CITY OF TAYLOR, TEXAS

PLANNING AND ZONING COMMISSION MEETING

April 13, 2021, 6:00 P.M.

City of Taylor
Taylor 70 Minor Plat
PZ-2021-1274
Staff Report

PRELIMINARY PLAT OF HUTTO SPORTSPLEX

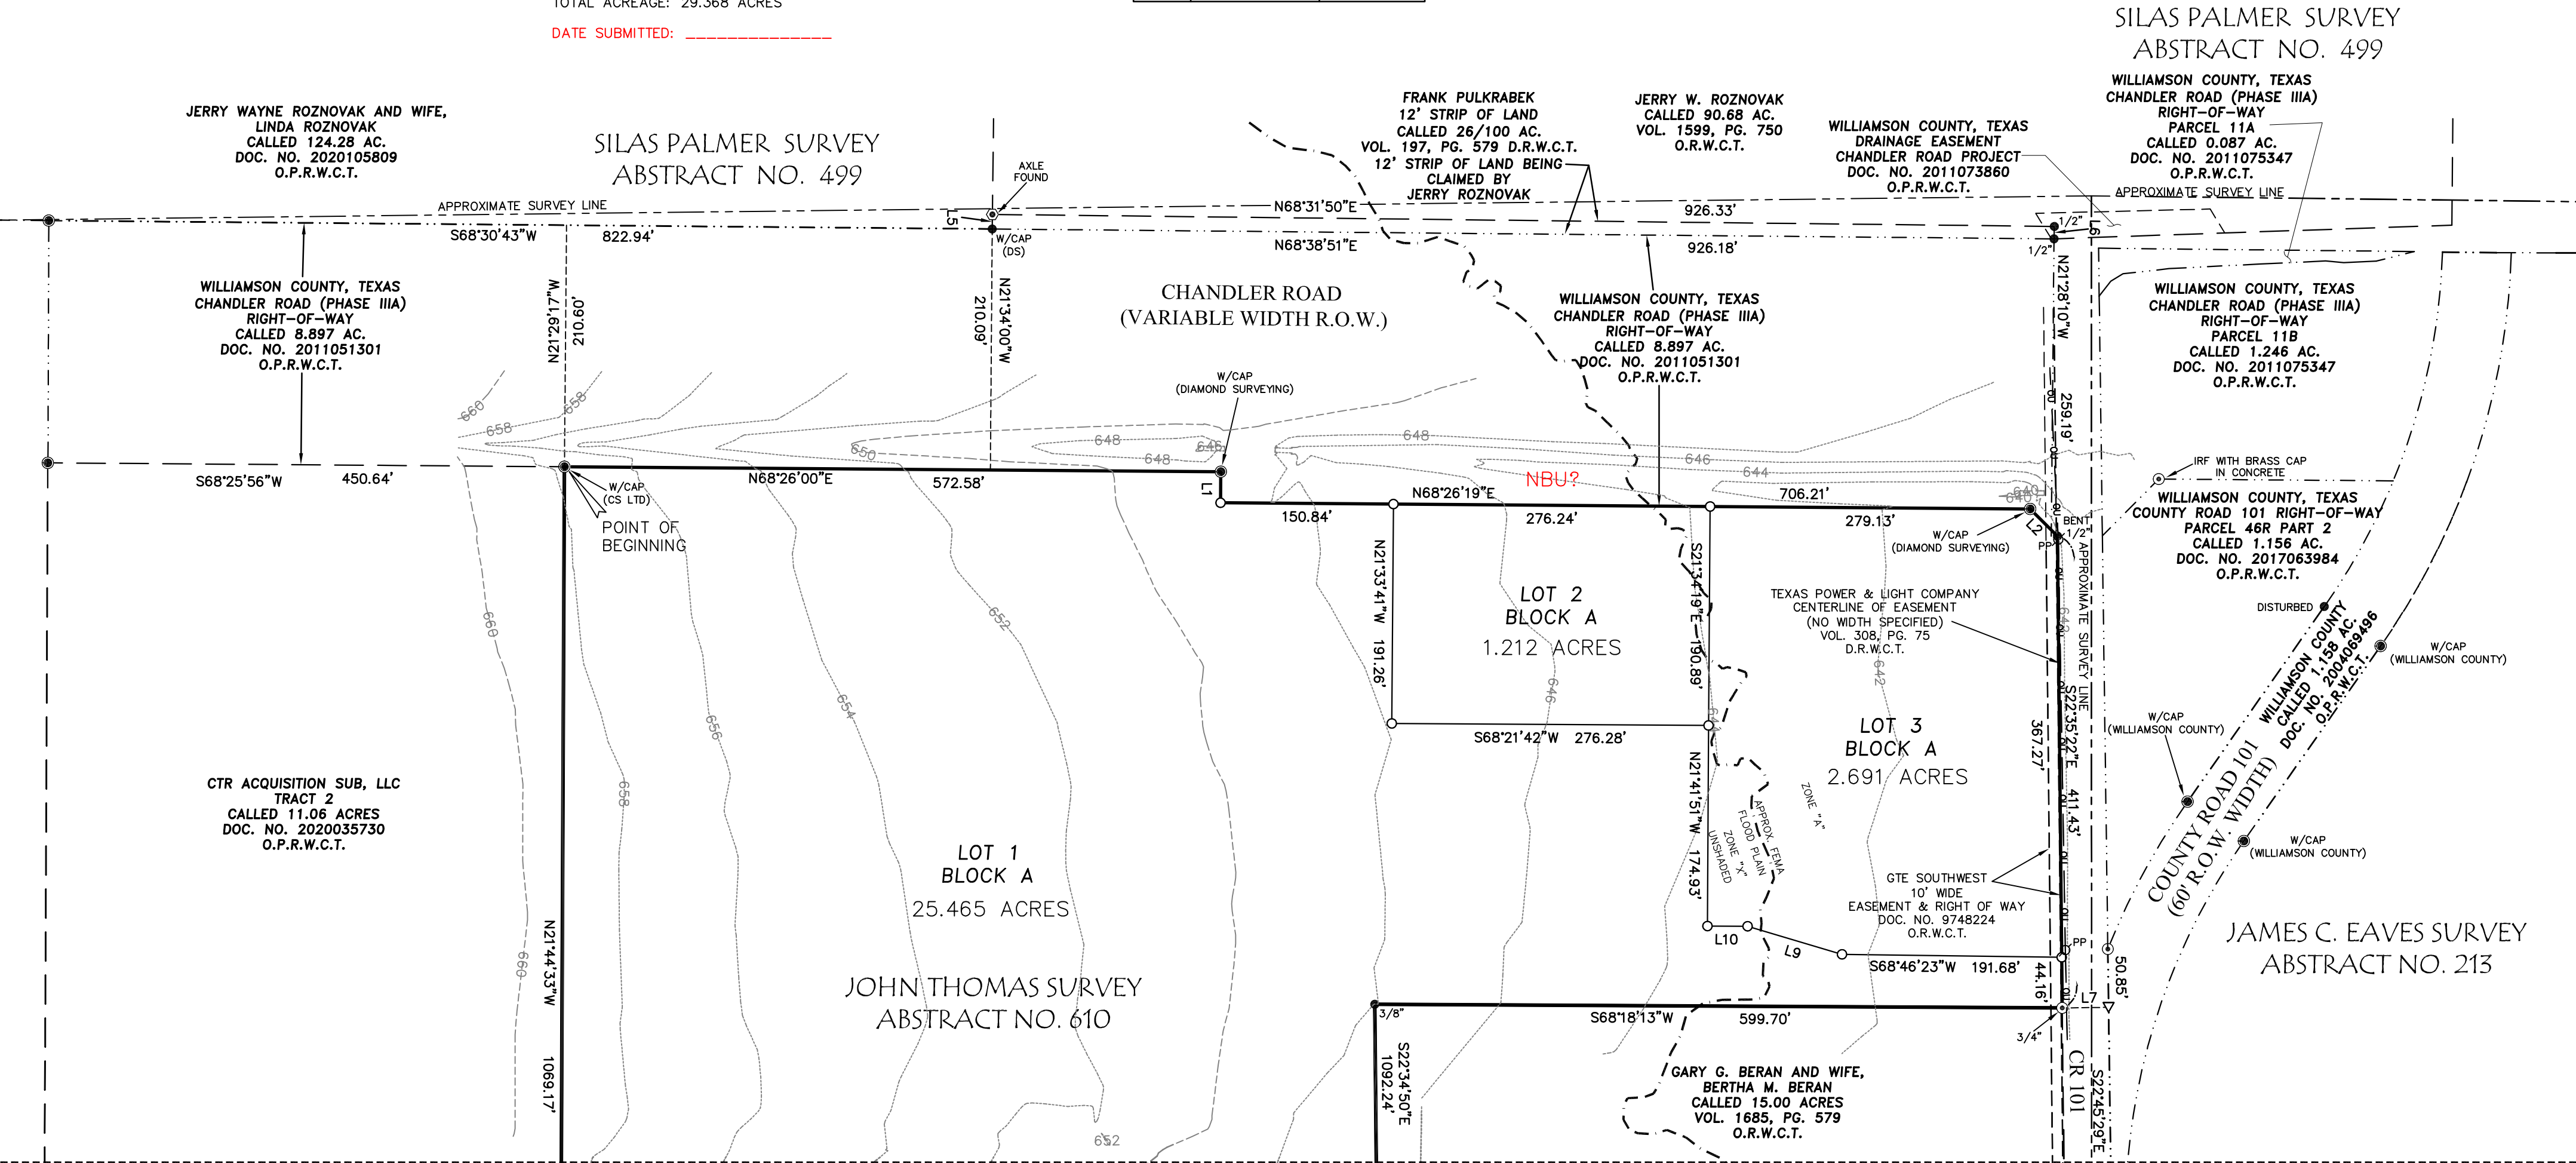
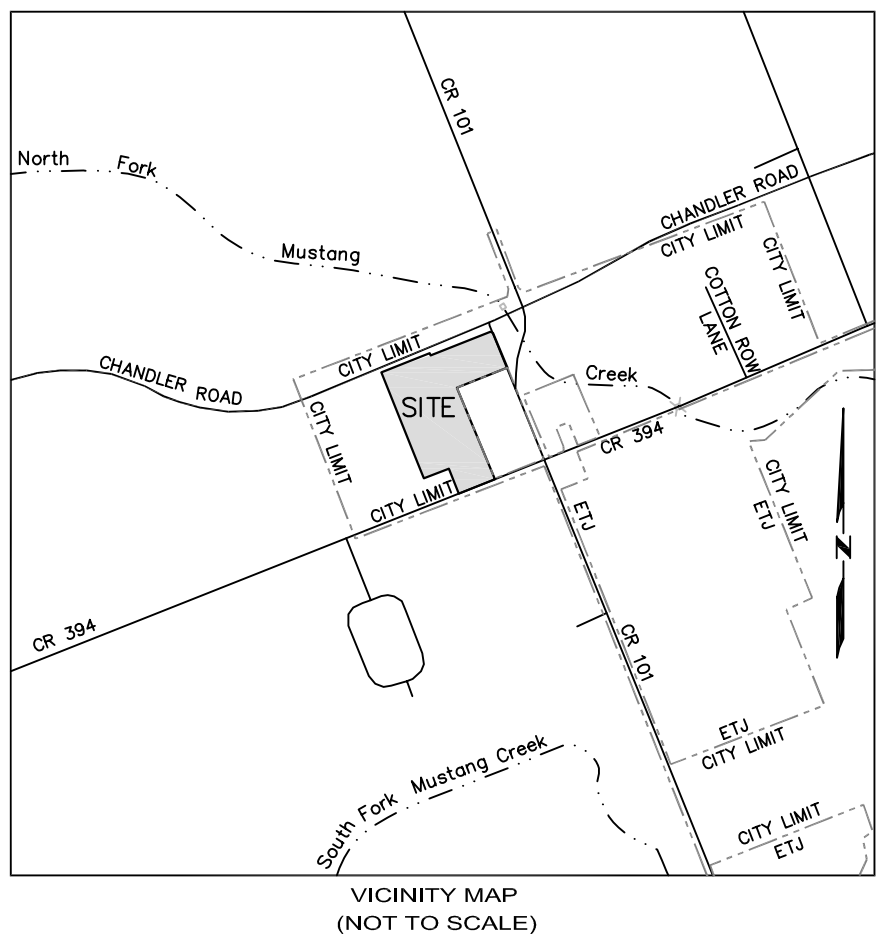
- c. Provide a tie to an original corner of the original survey of which said land is a part.

4. Remove Notes G. and I.

8. Provide the right-of-way dimensions. Stating that right-of-way width is variable is not adequate. It's not possible to tell if dedication is needed.

9. The Site Plan you provided and the plat are not consistent with each other. The plat could be one lot. Is there a reason why you are creating three lots? If the plat is one lot then the parking lot and Lot 2 do not have to match. If Lot 2 is for the building only then you will need a shared access and parking agreement that is recorded and notated on the plat by instrument number. If you create one lot then you will not need a shared access and parking agreement.

Provide an easement along Chandler Road that is 10 feet wide. Also, show drainage easements. See Subdivision Excerpt below:

13. Remove the land uses listed in the Table. The correct land uses need to be used is you want to notate it there. The land uses can be listed in the General Notes.

1. Provide additional information for ITE trip generation count for peak hour trips (PHT). Provide information on ITE manual version used and which code was used to determine the PHT.

2. Complete the contact information for the Engineer shown on page 1 of the plat.
3. Provide complete plat heading information (i.e. complete legal name of the subdivision).

4. Provide a tie to an original corner of the original tract and to the closest platted lot per per Subdivision Ordinance 3.2.9c and Subdivision Application – Plat Content 6b.

5. Provide and show a 10-ft utility easement along all road frontages as described in the plat notes.
6. For floodplain areas shown within the subdivision, the areas within the floodplain shall be shown as drainage easements per Engineering Manual 8.20.3a and Subdivision Ordinance 3.3.10a.

7. Show all water features within or adjacent to the subdivision per Subdivision Ordinance 3.2.11
8. Verify detention requirements for the subdivision and provide an easement for the subdivision per Subdivision Ordinance 3.3.10a.

9. Verify and show the easement encroachment near CR 394 for the Texas Power & Light Company.
10. Provide right of way information for CR 101 and verify if right of way dedication will be required.

11. Verify right of way dedication requirement for CR 394.
12. Verify requirements for Jonah Water regarding utility easements or additional requirements based on the District Engineer review.
